GJS Plot F, Manchester

Non-material Amendment | 25.09.2024

Z1-SHP-A180-RP-XX-NMA02 | P05

Updated Proposal - F2-SHP-G200-PL-Grd-B5D801 - P06

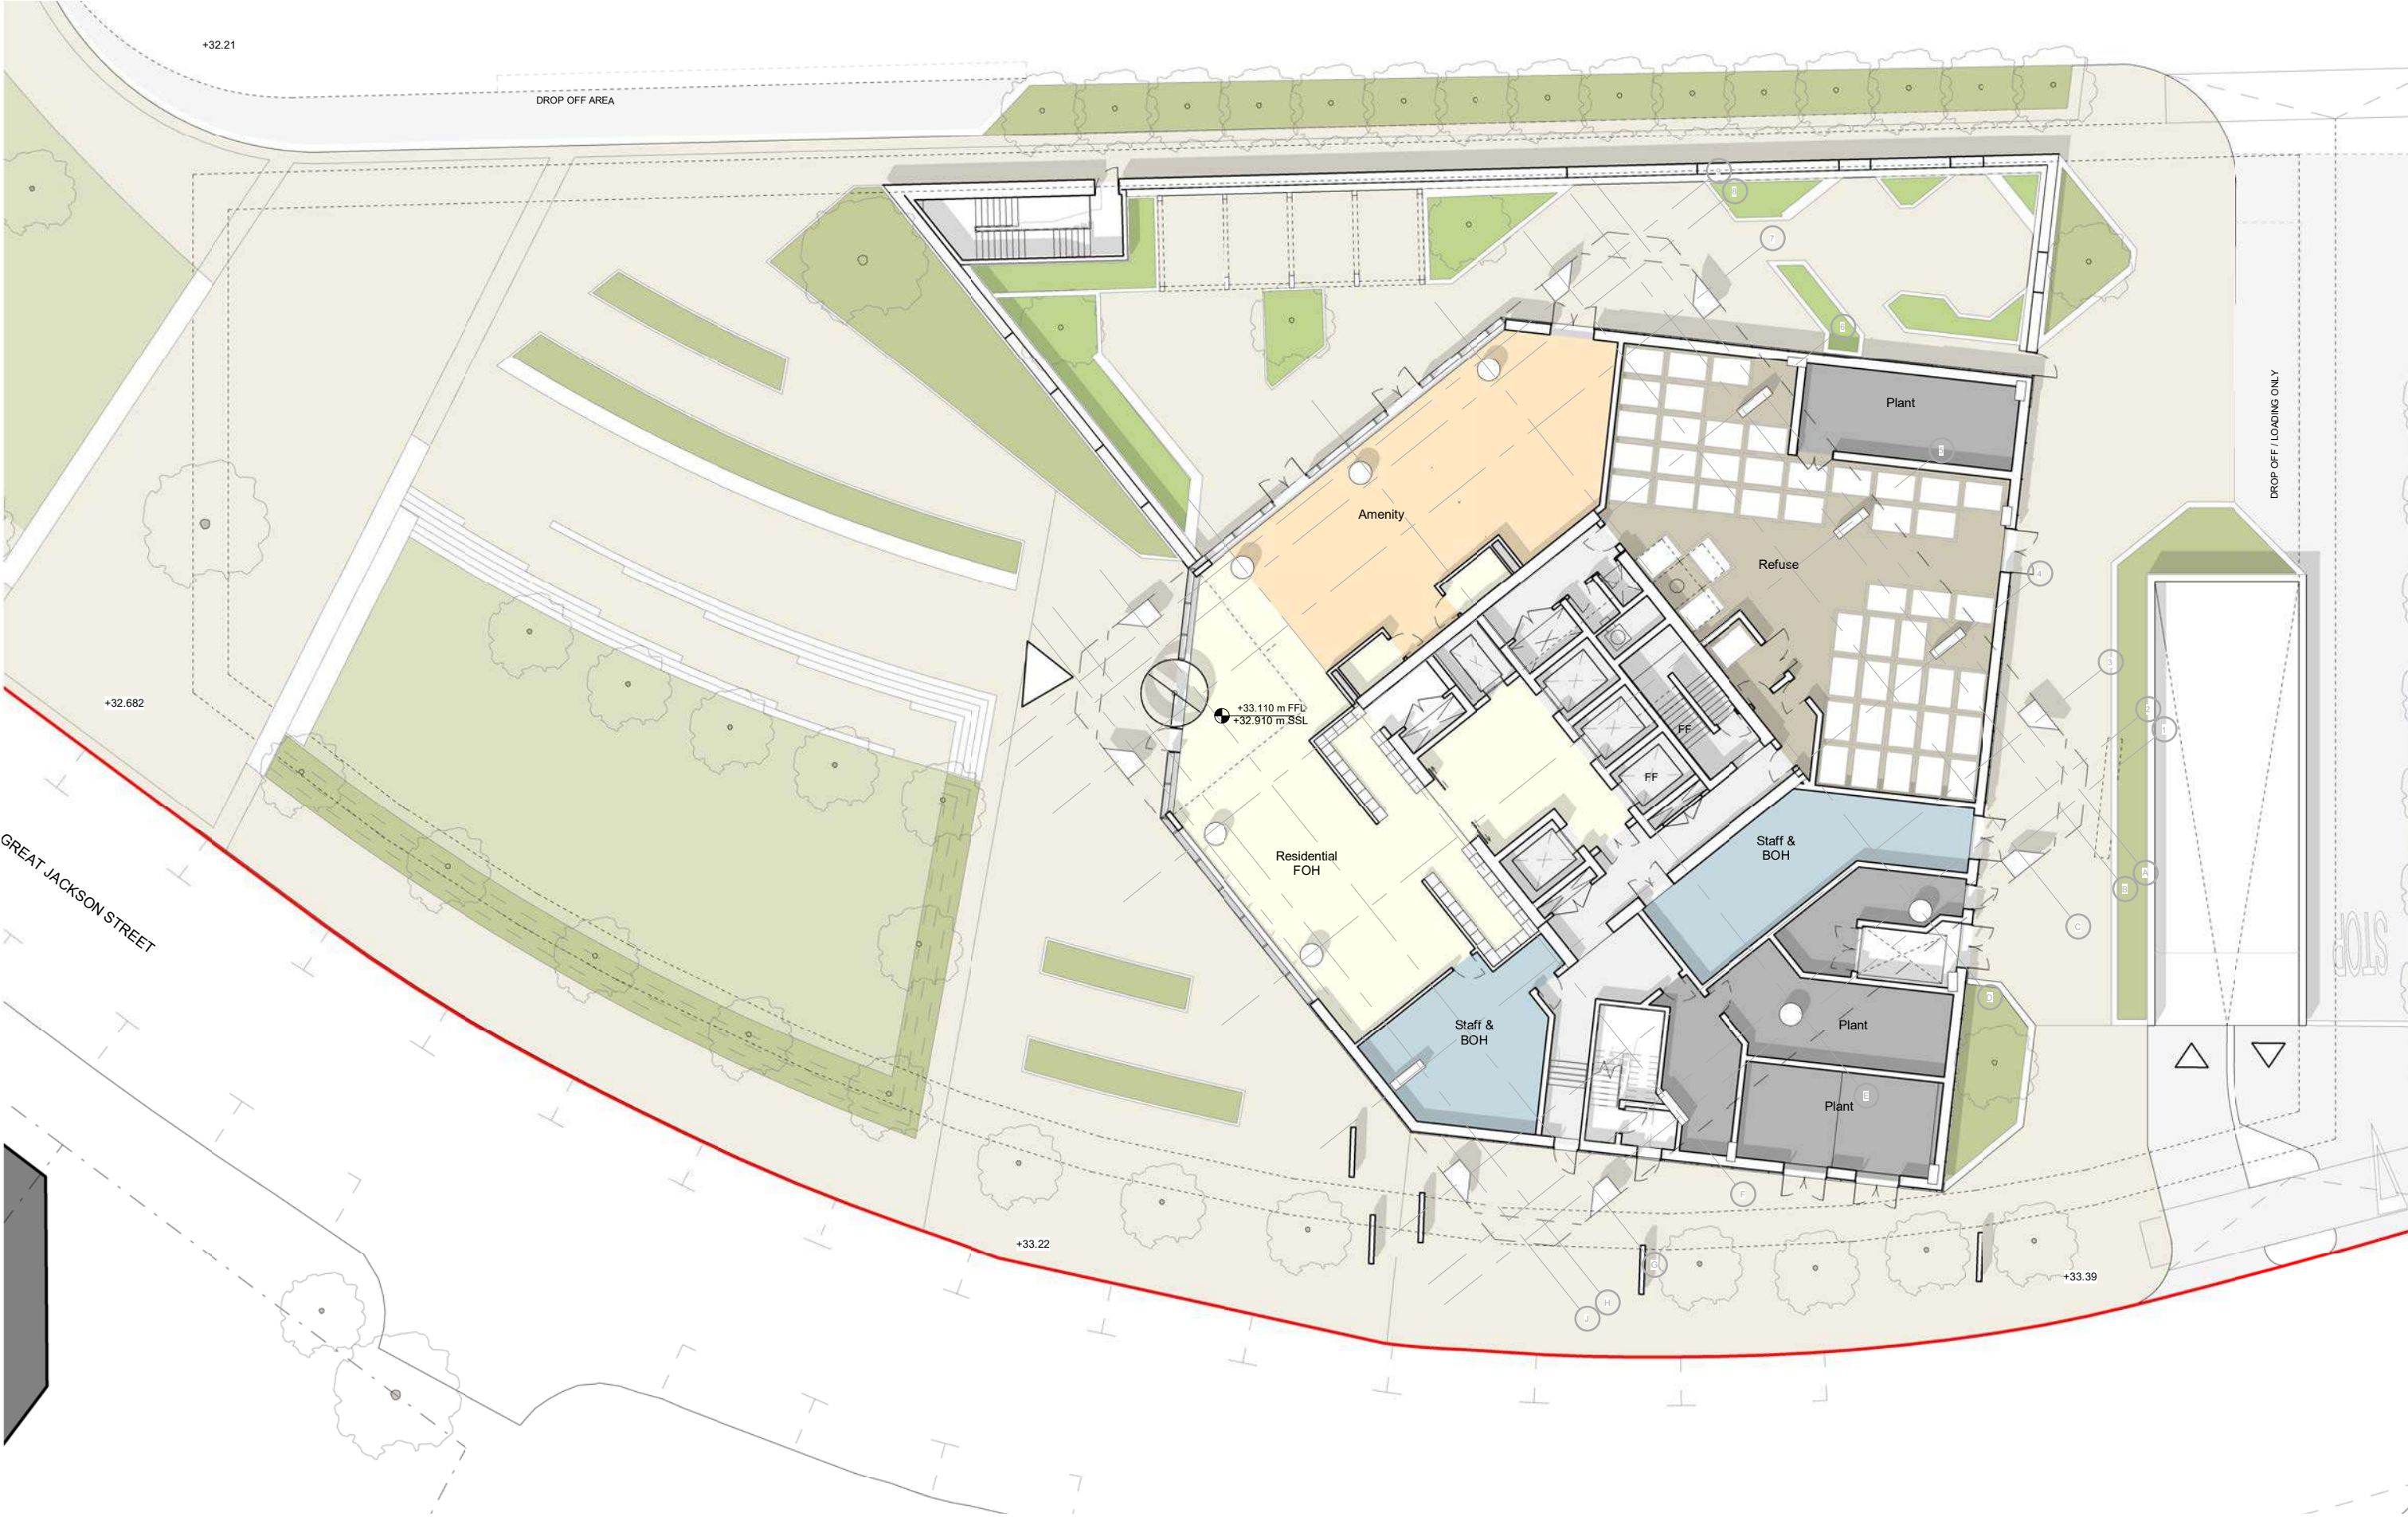
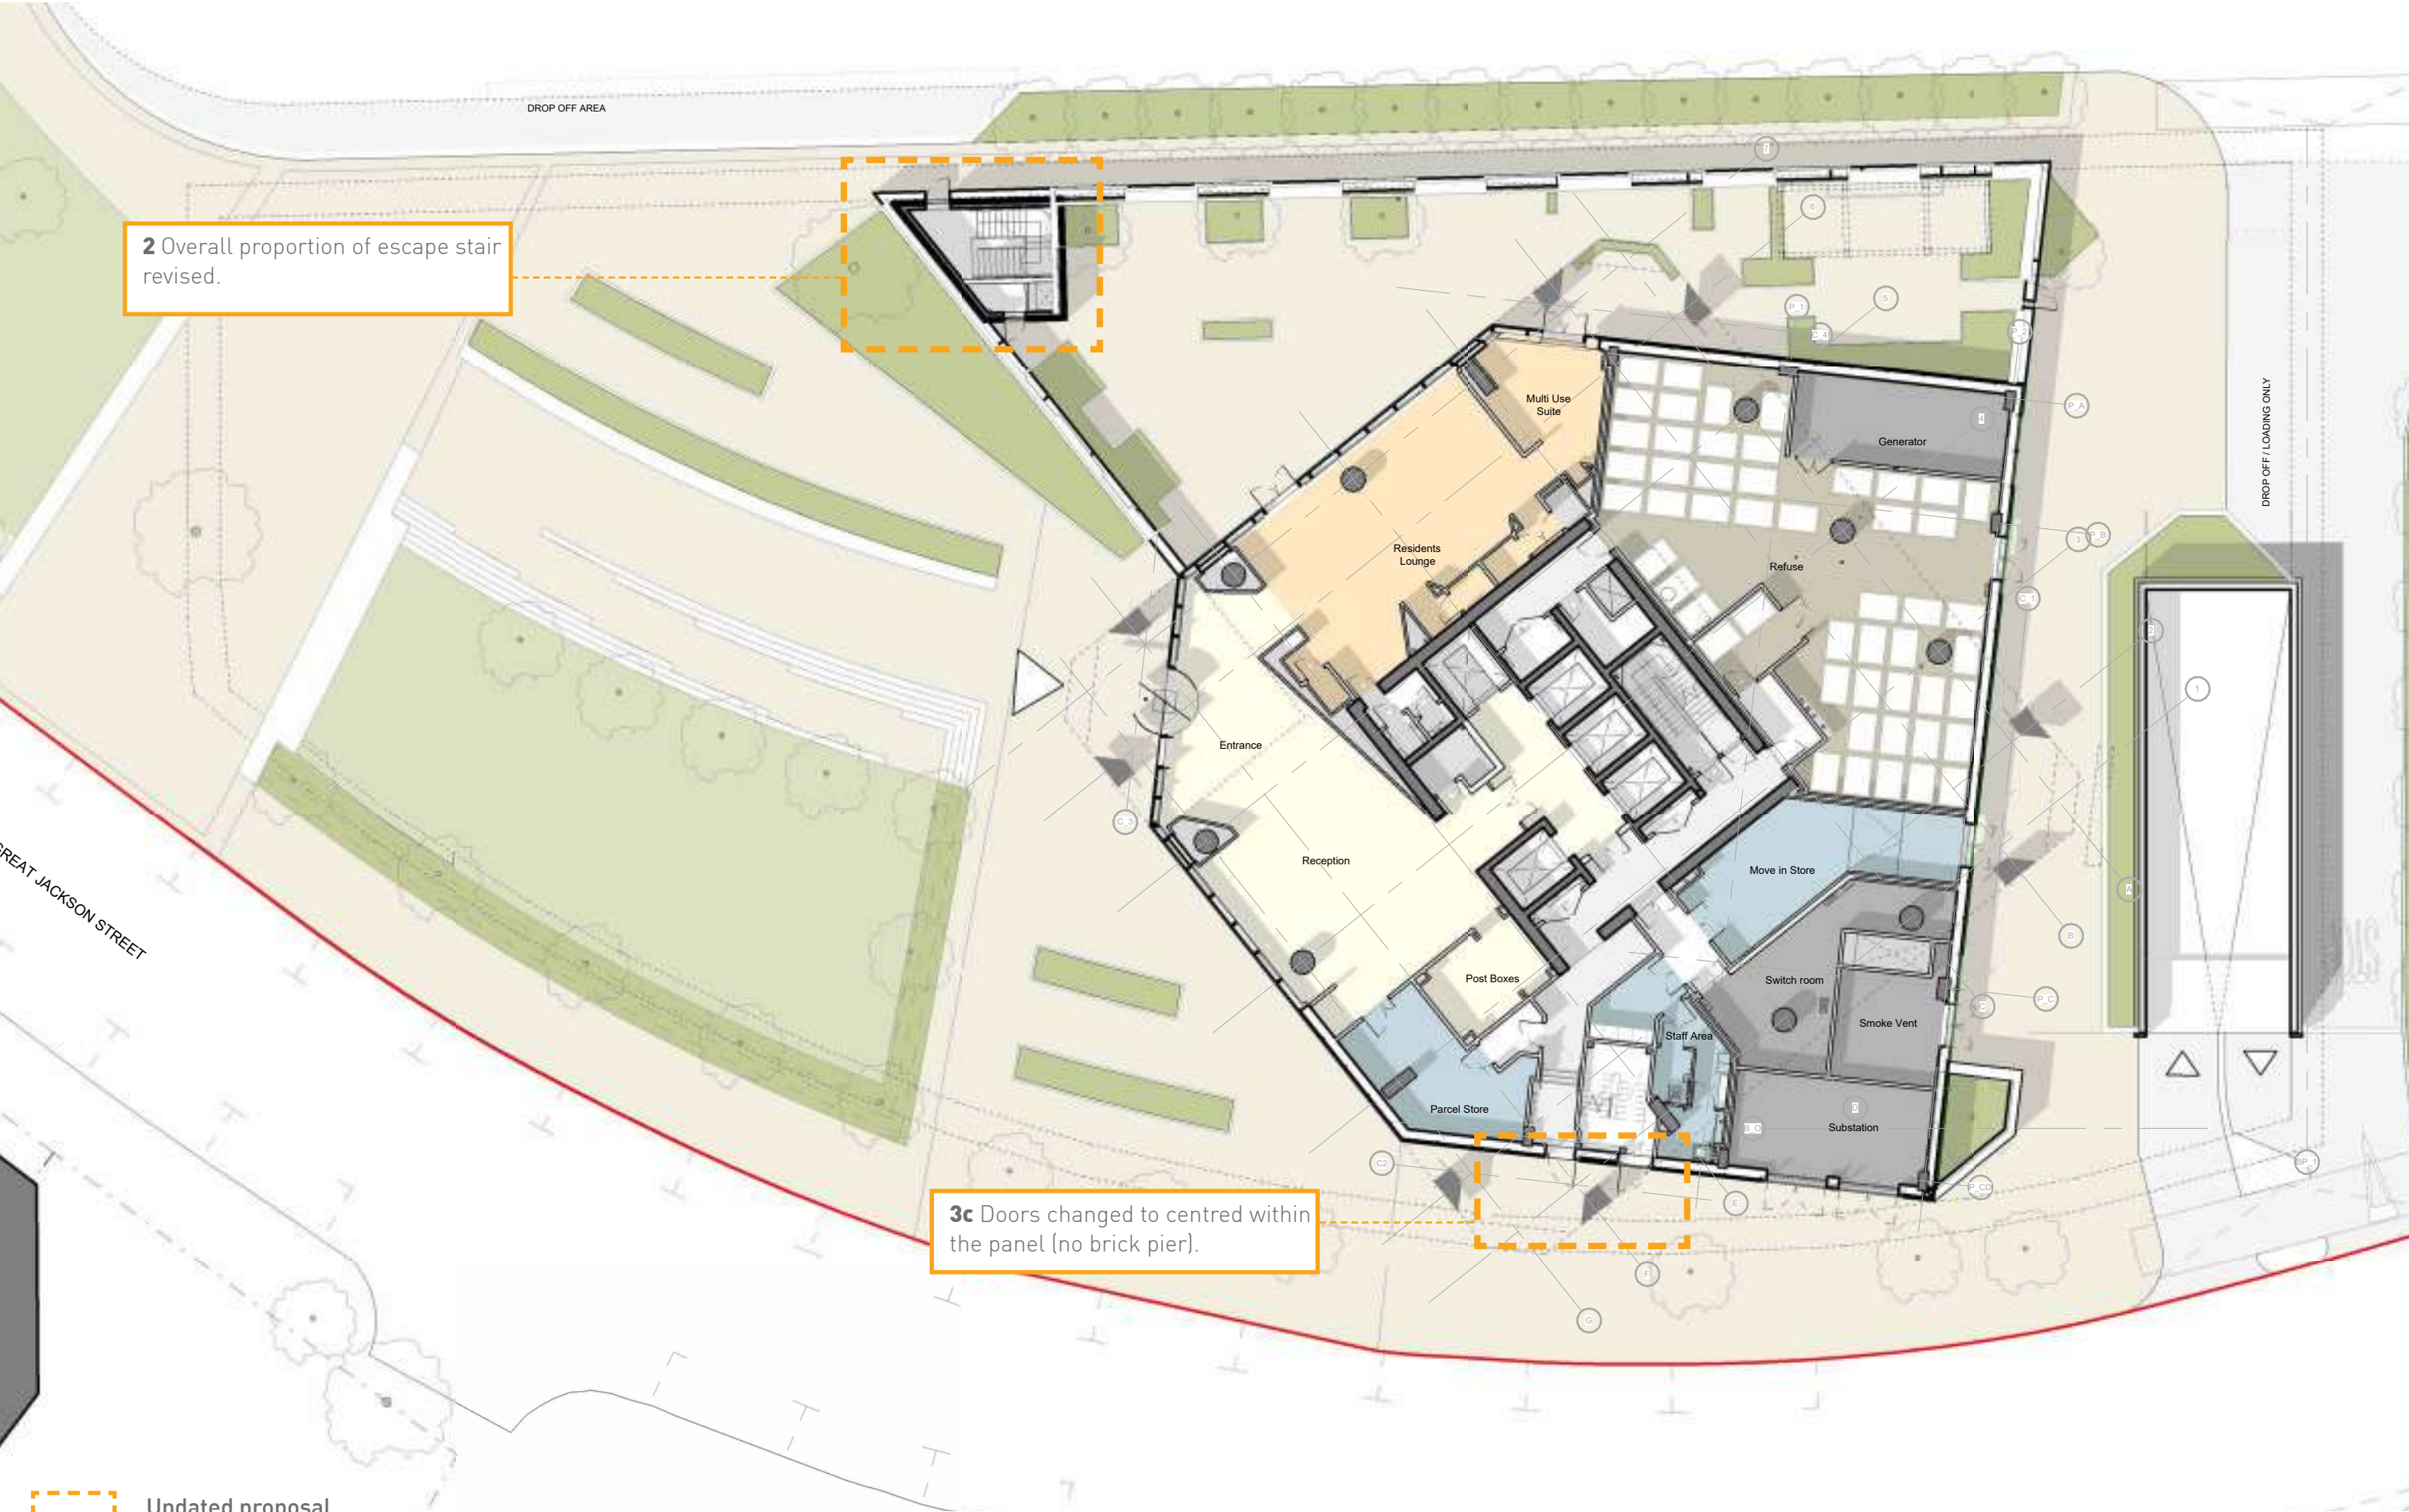
2.	Tower F2 - Pond Street escape stair The standalone escape stair that forms part of the F2 garden wall has been reduced in length but increased in width slightly to accommodate a smoke extract shaft to the stair lobbies. The overall footprint is similar to that of the consented scheme.
